ADDENDUM, CONSTRUCTION CHANGE DOCUMENTS, DRAWING, DEFERRED APPROVAL WORKSHEET AND TRANSMITTAL MEMO

Project Name/School: Sutter Middle School (Sacramento City USD)		DSA File #: 34	- 53
<input type="checkbox"/> Change Order #:	<input checked="" type="checkbox"/> Addendum #: 01 (Sub 1)	DSA App.02	- 115661
<input type="checkbox"/> Deferred Approval:	<input type="checkbox"/>

NO.	DESCRIPTION	DATE	BY
AD	HEALTH		
PROJECT: NAVA			
SUTTER MIDDLE SCHOOL - HVAC REPLACEMENT			
1	DELETE		with 5

November 10, 2017
Addendum No. 01
Sutter Middle School – HVAC Replacement
Page 5

15 DUCT @ (E) 1/2" = 1'-0"

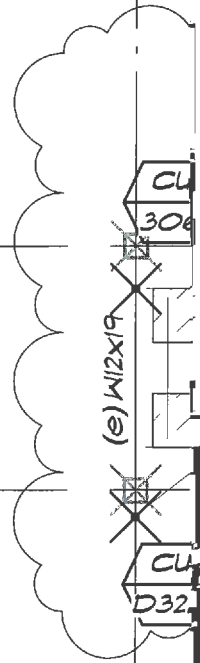
1. ~~ADD General Note 7 to read "Refer to Detail 15/A8 1.1 for DuctSox duct wrap~~
